RESPONSE TO COMMENTS

SUMMERSIDE WEST PHASES 4, 5, & 6

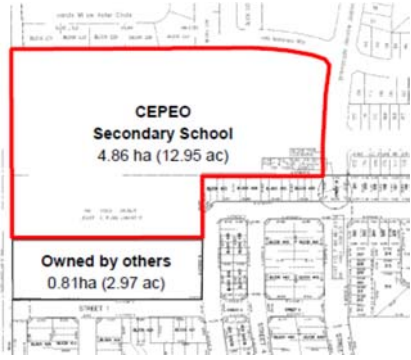
<i>F. ENVIRONMENTAL COMMENTS</i>		
F1. PIED (Jennifer Boyer) Comments received from Shoma Murshid June 22, 2018	<p>The Geomorphologic Concept Plan for McKinnon's Creek, 2017 was submitted with the first submission for review on December 19, 2017. As noted on the Response to Comments table (#6, pg.3), that this plan overlays the various components of McKinnon's Creek hazard limits, which are considered non-developable. Maximum Potential Extent of the Corridor width as shown on this plan, from the meanderbelt hazard limit. The extent of the meanderbelt and the McKinnon's Creek corridor was then to be overlaid on the Draft Plan of Subdivision and the Subdivision Concept Plan.</p> <p>As noted in the comments from City Staff dated January 22, 2018, the Draft Plan of Subdivision overlaid the McKinnon's Creek Corridor Plan in which the maximum width of the hazard limits extending into the area of the proposed development, namely Streets 8 and 22.</p> <p>The Response to Comments (#7, pg.3) states that even though SNC and City staff state there is minimal room for a pathway, the response to comments states that the above noted plan is</p>	<p>Please see the enclosed memo from Muncaster (dated August 3, 2018), which addresses these comments. The revised Draft Plan of Subdivision (dated September 25, 2018) reflects the hazard limits and associated setbacks, including the "Maximum Potential Extent of Corridor" from the CDP EMP.</p>

Commenting Agency	Comment	Response
	<p>sufficient for draft plan approval purposes. Yes, the McKinnon’s Creek Corridor Concept plan is sufficient, however the Draft Plan of Subdivision illustrates Street 8 encroaching into the meanderbelt hazard limit on the west side of McKinnon’s Creek; and Street 22 on the east side of McKinnon’s Creek.</p> <p>The Draft Plan of Subdivision requires the surveyed setback distance shown in the Creek Corridor with arrows showing the proper distances to delineate the correct setback. Currently, according to measurements, there are 8 metres missing off the west side of the meanderbelt on the Draft Plan of Subdivision. This requires revision to reinstate the full setback, and there is currently no room for a MUP pathway system.</p> <p>As noted in the Environmental Management Plan, the meanderbelt hazard limit and setbacks for McKinnon’s Creek are non-developable. Any refinement to the setback of the corridor, through the completing of a site specific Environmental Impact Statement was to ensure the ecological integrity of the creek and if/ and where to properly locate any pathway outside the hazard limit; discuss the rehabilitation options for the creek, headwater drainage feature recommendations, and any off-setting requirements.</p> <p>Based on a preliminary review of the 2nd submission package for 2564 Tenth Line (Summerside West Phases 4, 5 and 6), I am unable to provide Draft Plan Conditions at this time. The Draft Plan of Subdivision requires revision to accommodate the McKinnon’s Creek corridor, as noted above.</p>

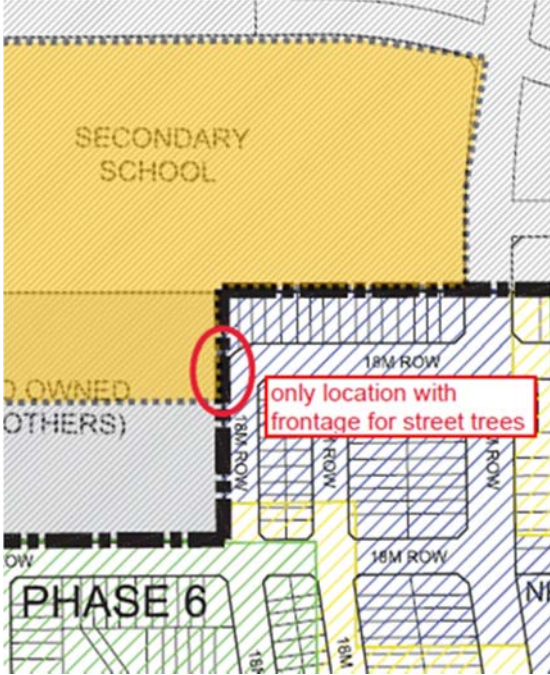
<p>F2. South Nation Conservation Authority</p> <p>Comments received from Shoma Murshid August 14, 2018</p>	<p>The Tree Conservation Report and Environmental Impact Statement was reviewed in the context of the Environmental Management Plan (EMP), prepared by Morrison Hershfield Limited.</p> <p>SNC accepts the responses to our comments, dated January 22, 2018, with the exception of comment #4, which stated: <i>The description of the headwater drainage features and management recommendation reflects the Headwater Drainage Feature (HDF) report completed by Bowfin Environmental;</i></p>

Commenting Agency	Comment	Response
	<p><i>however, no detail is provided on the implementation of the management recommendation.</i></p> <p><i>The EMP states in Section 10 (page 134), that this will be refined during detail design. Please include a discussion of how the recommendations of the HDF report will be implemented.</i></p> <p>The report provides three measures to achieve the HDF management recommendations. We offer the following comments on the revised report:</p> <ol style="list-style-type: none"> 1. The first measure states that there will be an increase in flow contributions from the SWM pond to McKinnon's Creek, which will increase the duration of available fish habitat. The pre and post development flows from the SWM pond must be the same. Please clarify and provide calculations if the flows will indeed change. 2. The extensive planting of trees and shrubs along McKinnon's Creek is not an appropriate mitigation measure for the loss of the HDFs. This planting will already be required as part of the rehabilitation planting plan, and shouldn't be counted twice as mitigation. Further, there should be discussion on the use of well-vegetated swales, constructed wetland features, LID features, etc. to replicate the functions of the HDFs. 3. Please describe the wetland habitat that will be created adjacent to the expanded SWM pond and how it mitigates the loss of the HDFs. Is this a new wetland feature or already part of the design for the SWM pond expansion? The creation of amphibian habitat elsewhere along McKinnon's Creek cannot be counted twice as mitigation if it is already part of a rehabilitation plan. 	<ol style="list-style-type: none"> 1. Maybe 'flow' is the wrong word – Muncaster's understanding from IBI was that the base flow during the lower flow periods would last longer as the hydrograph is smoothed out by the SWM pond. This would be beneficial for fish habitat as McKinnon's would have more useable fish habitat over a longer period 2. Please see page 2 of the August 3, 2018 memo from Muncaster for the mitigation measures for the loss of the HDF. 3. The wetland habitat will be separate from the stormwater management pond itself. The objective is to create amphibian habitat that is separate from where the fish are most likely to be. Gentle side slopes (eg. 3- 1) will be used, with typical water depths between 0.6 and 1.4 metres. Aquatic plants will be planted. See the HWF compensation amphibian pond approved by RVCA for Stittsville development, which is attached to Muncaster's memo (dated August 3, 2018).
